PSE&G Public Service
Electric and Gas
Company

August 10, 1984

HOPE CREEK GENERATING STATION
DOCKET NO. 50-354
DRAFT SAFETY EVALUATION REPORT
OPEN ITEM STATUS

Attachment 1 is a current list which provides a status of the open items identified in Section 1.7 of the Draft Safety Evaluation Report (SER). Items identified as "complete" are those for which PSE&G has provided responses and no confirmation of status has been received from the staff. We will consider these items closed unless notified otherwise. In order to permit timely resolution of items identified as "complete" which may not be resolved to the staff's satisfaction, please provide a specific description of the issue which remains to be resolved.

HOPE CREEK UNIT 1
 CAD. L 9A, REV 1

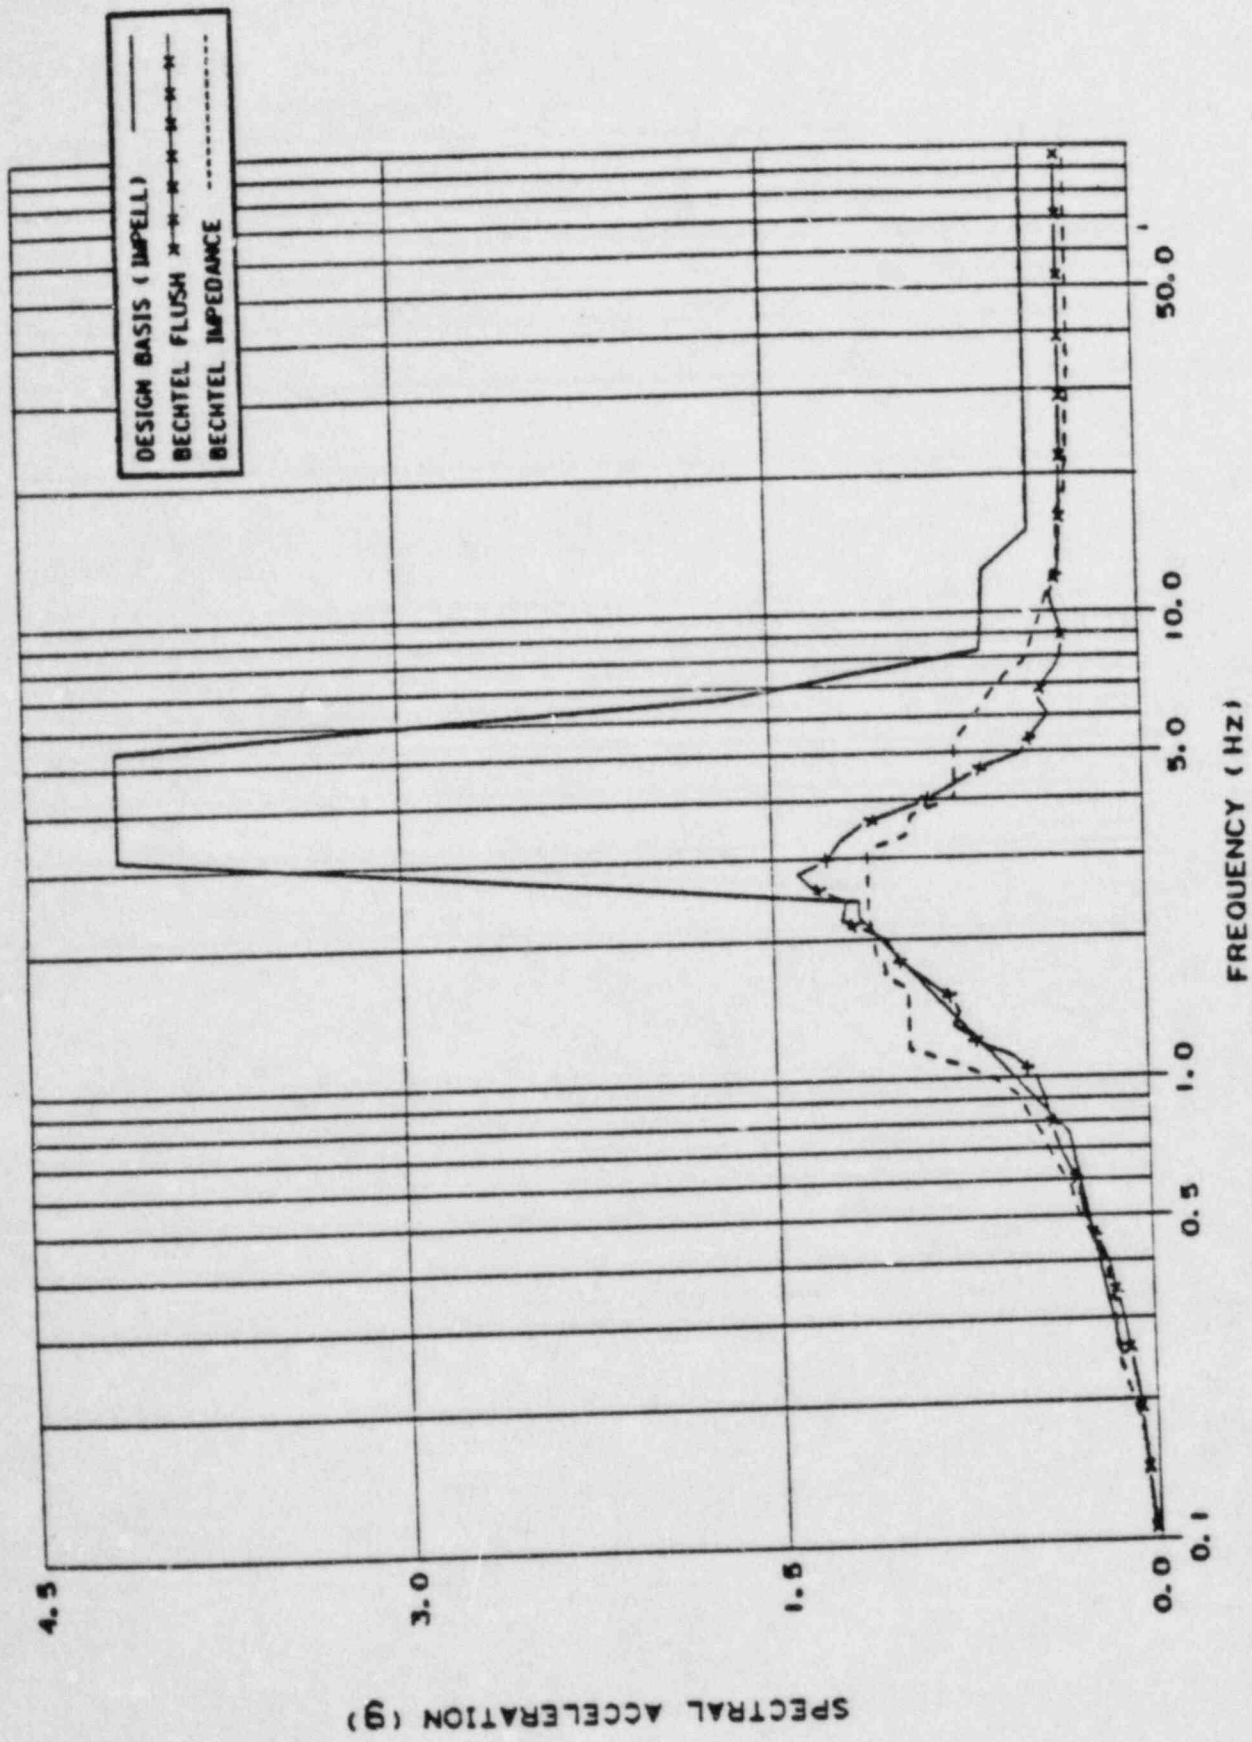
Question: Provide comparison of Bechtel Independent Verification Results with the Design Basis Results.

Figures A-13-2 to A-13-37 show the comparison of the response spectra (2% damping) obtained from the above three seismic soil-structure interaction analyses. Discussions of these comparisons are as follows:

The peak spectral accelerations obtained from the impedance approach analyses are generally lower than those obtained from the design basis analyses. However, these response spectra are not completely enveloped by those obtained from the design basis analysis, especially in the frequency range between 1.0 and 3.5 Hz. Also, there are some local exceedances in the higher frequency range, as shown in Figures A-13-2 through A-13-37.

FIGURE A-16-1
RESPONSE SPECTRA COMPARISON,
INTAKE STRUCTURE AT ELEV. 93' - 0",
N-S, SSE, 2% DAMPING

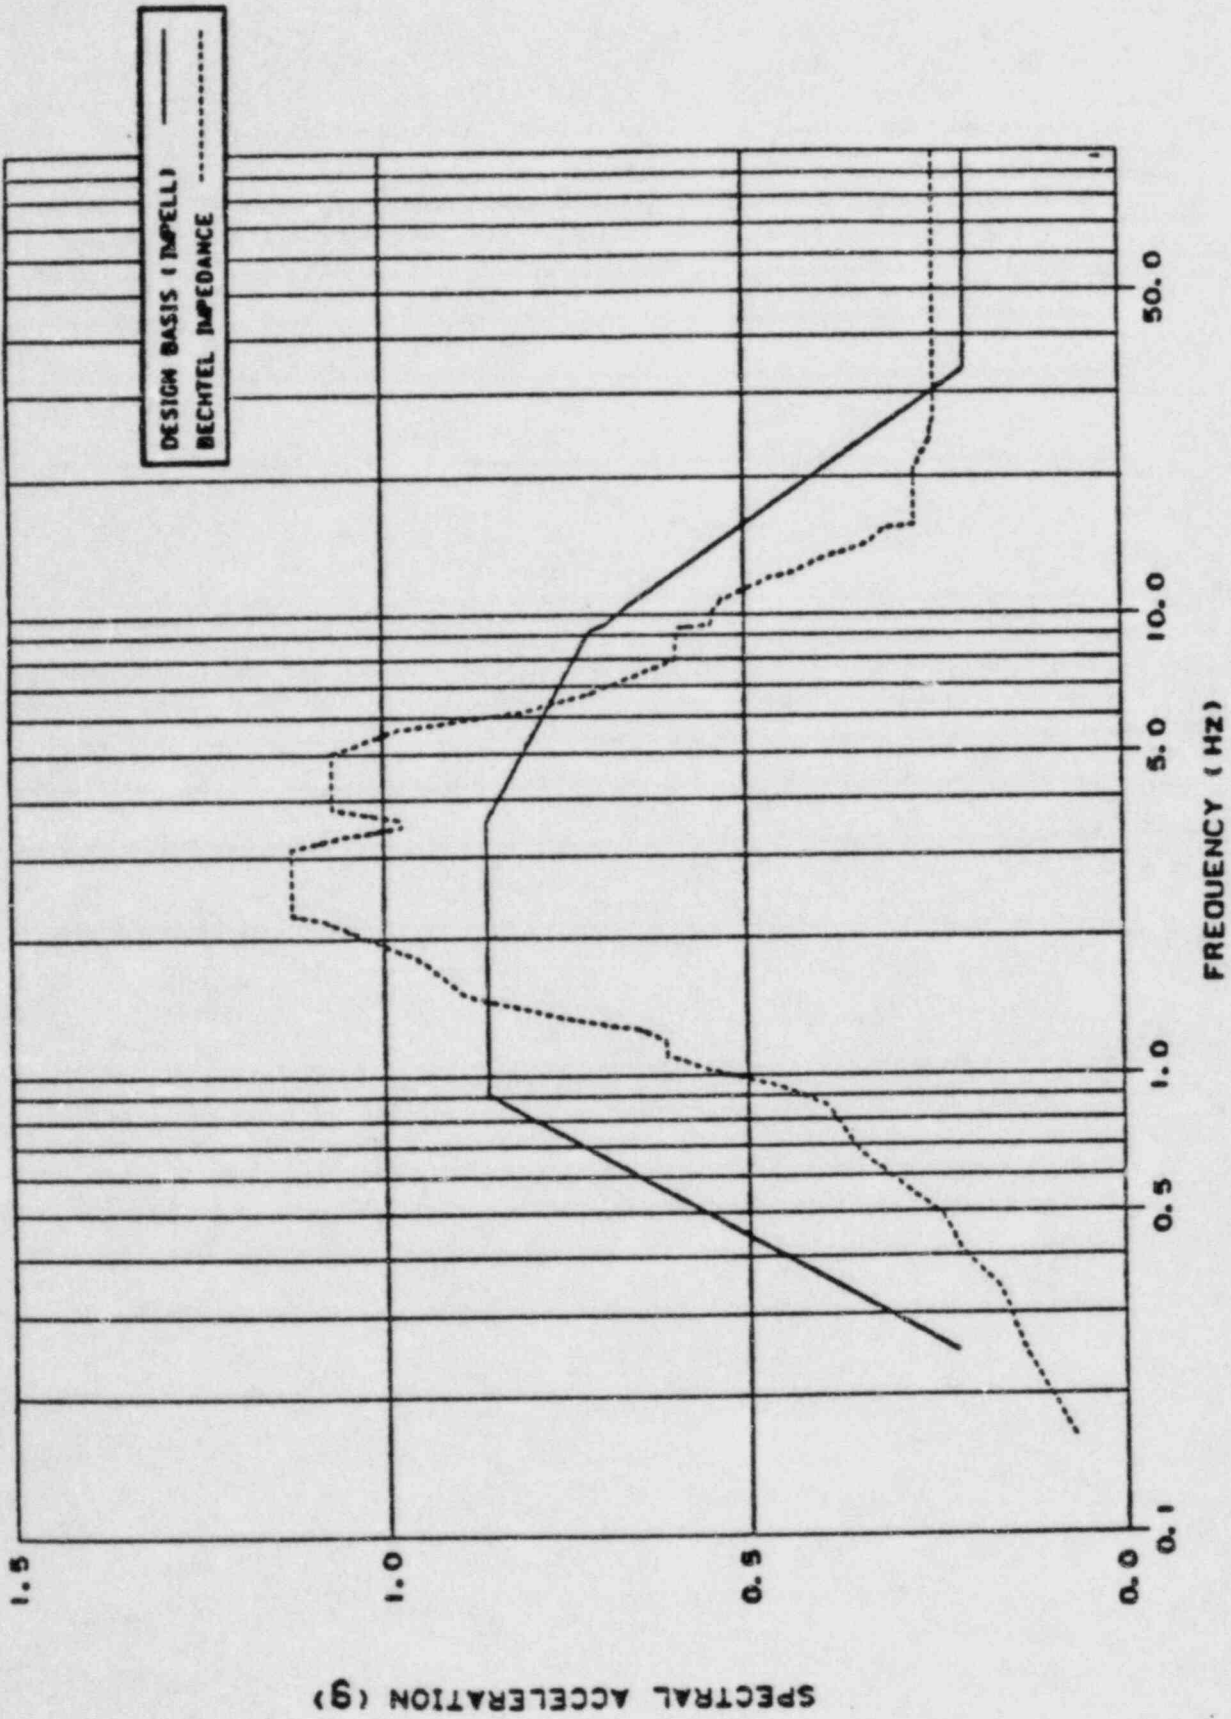
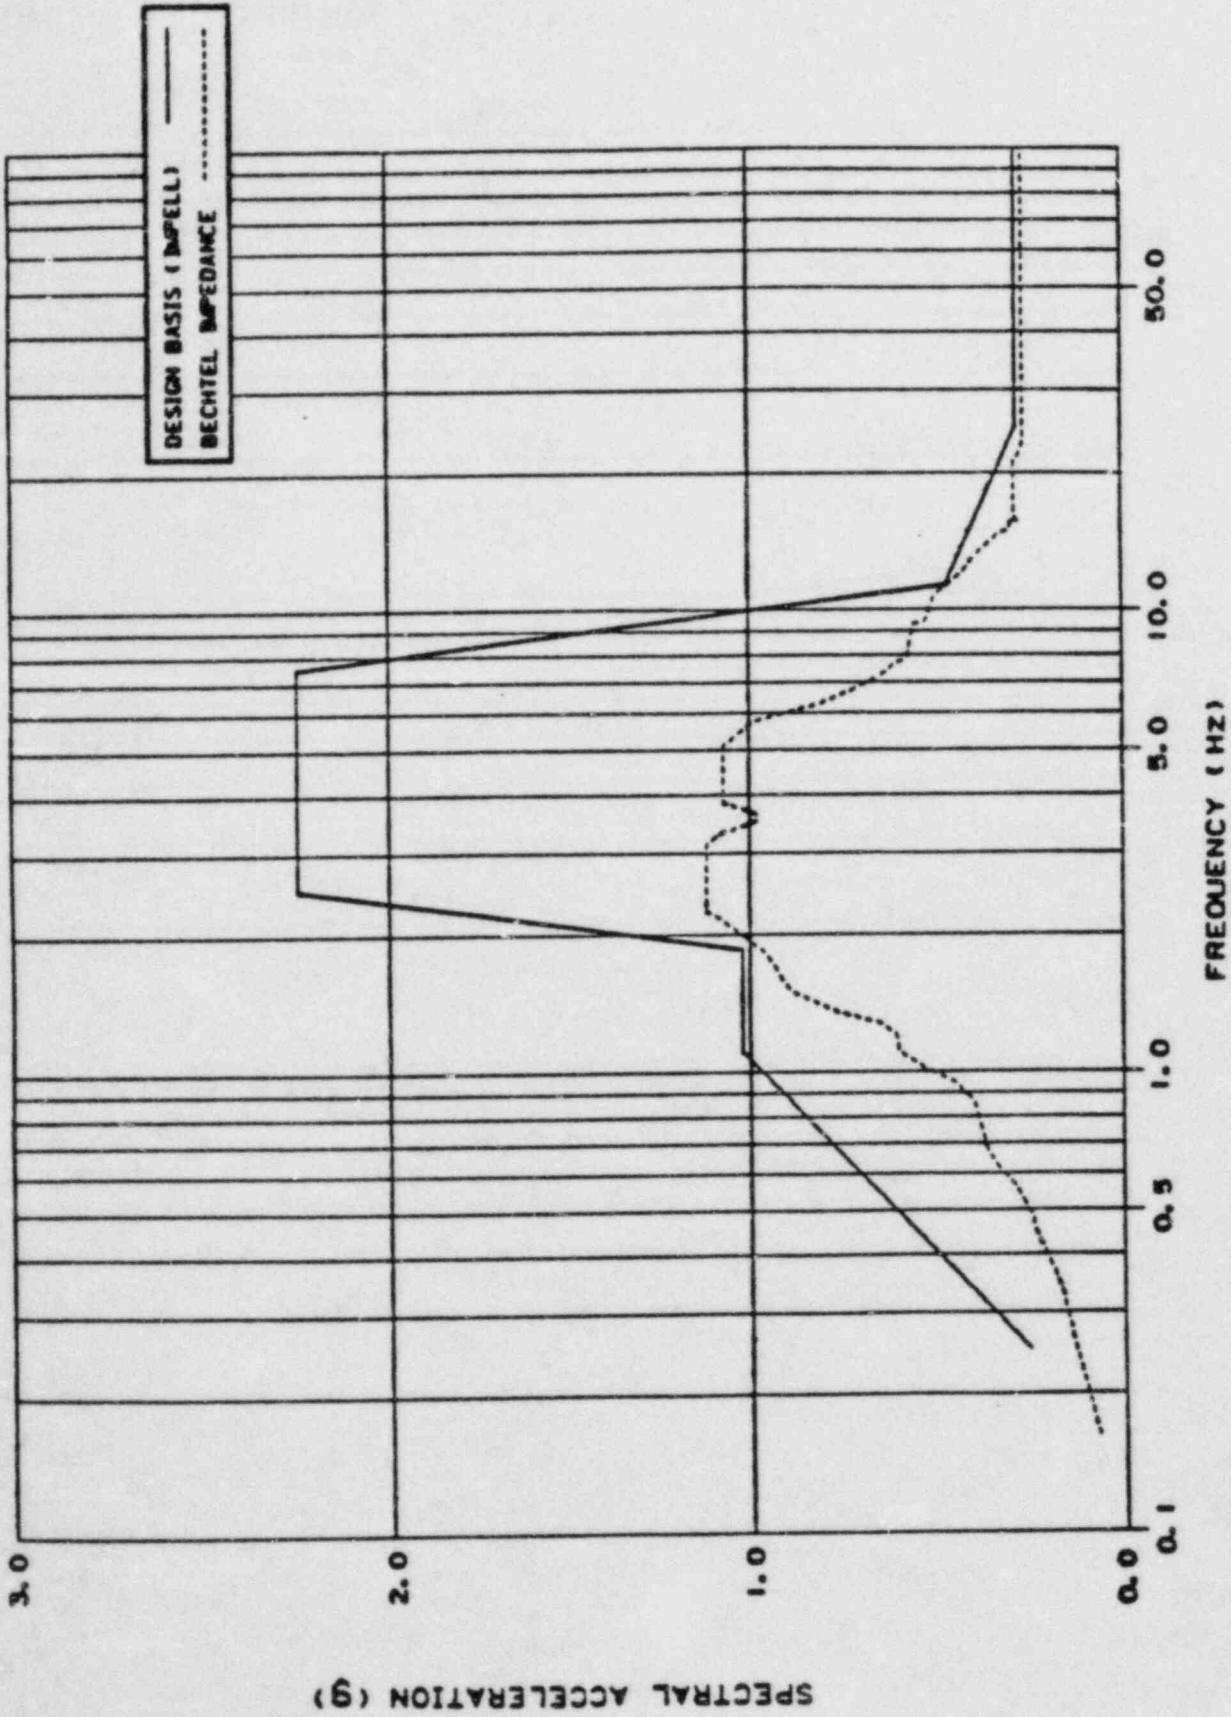
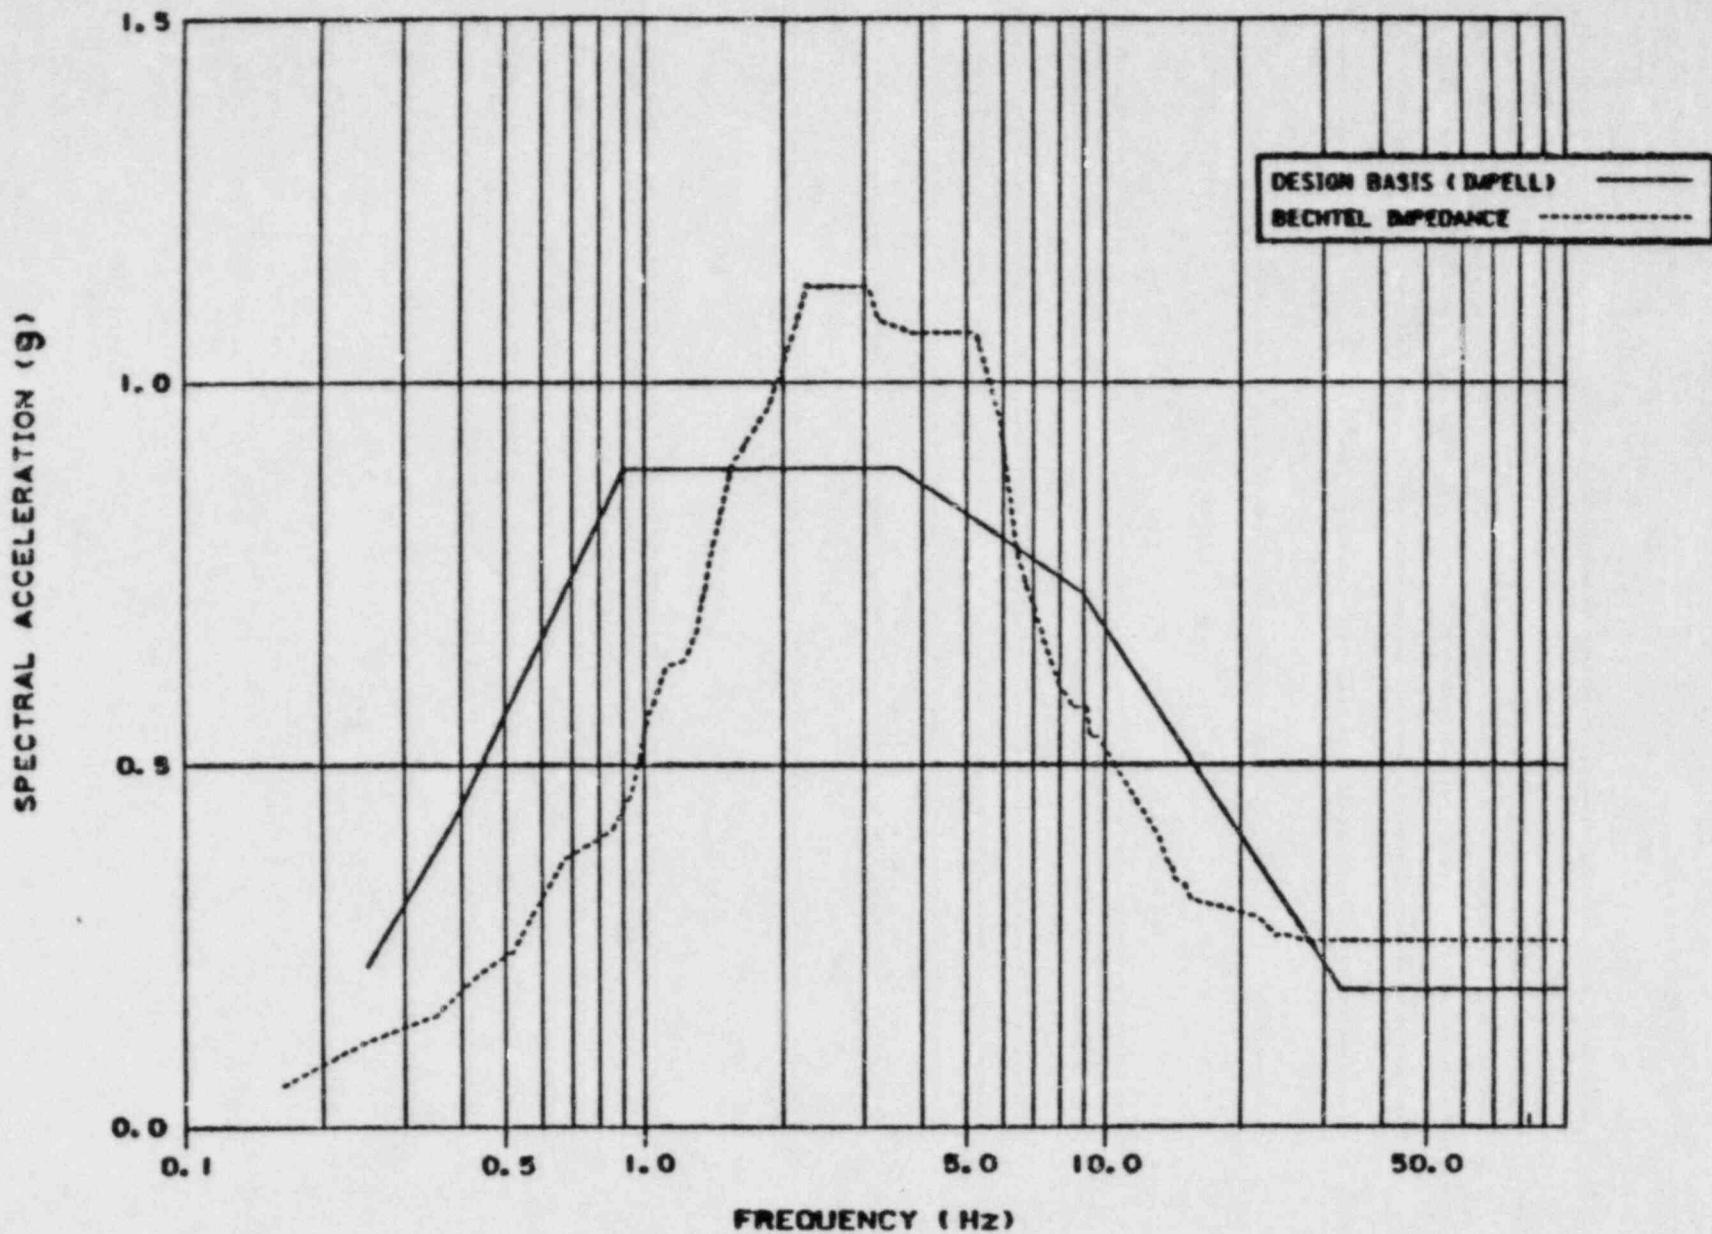
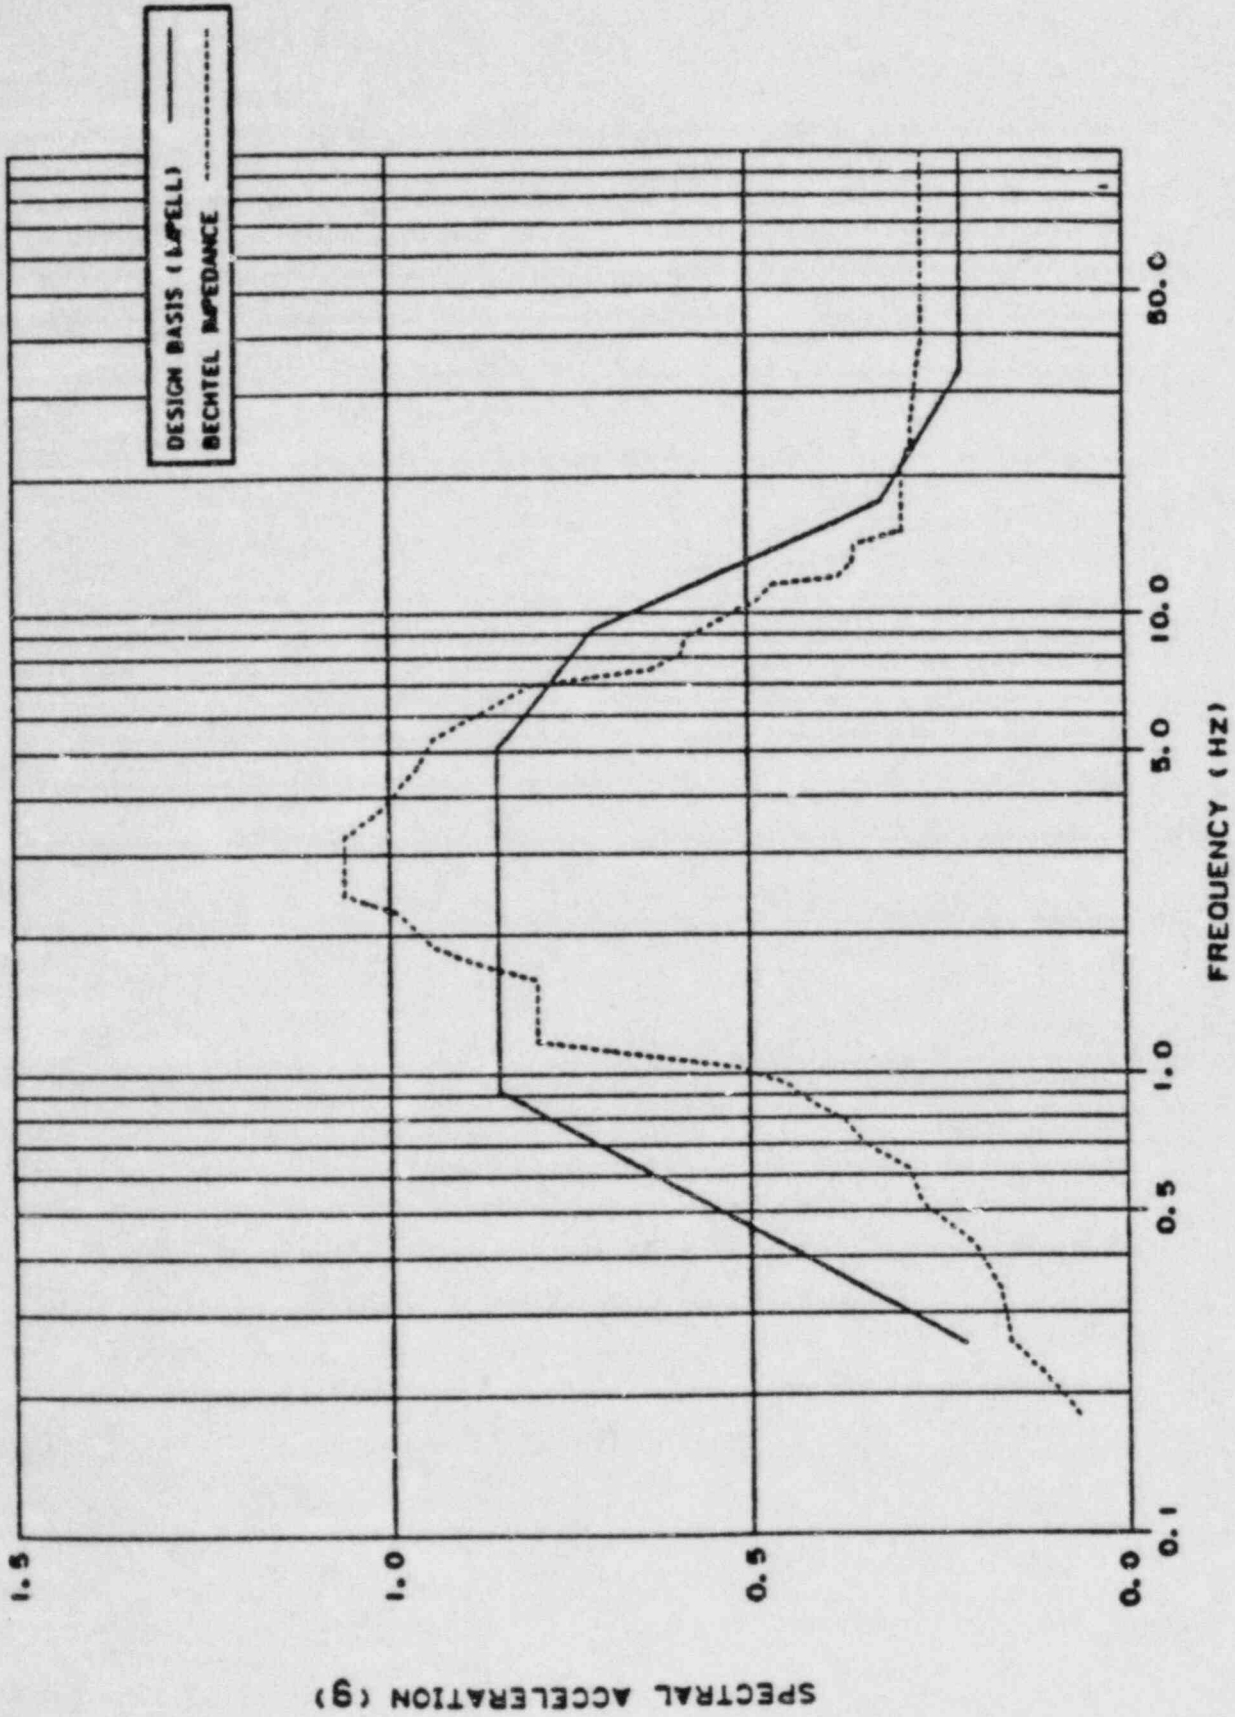
Question: Perform an independent seismic verification analysis (impedance analysis) for the intake structure and compare the results with design basis results. Consider the effects of side boundaries, embedment and the presence of water masses in the analysis.

Figures A-16-1 to A-16-18 show the comparison of the 2 percent damping response spectra obtained from the design basis finite element and the impedance approach seismic soil-structure interaction analyses. The impedance approach response spectra generally are enveloped by those obtained from the design basis analyses at elevation 114.0 feet of the SWIS. For other elevations, the impedance approach spectral accelerations exceed the design basis spectral accelerations in some frequency ranges. These ranges vary approximately between 1.5 and 10.0 Hz.
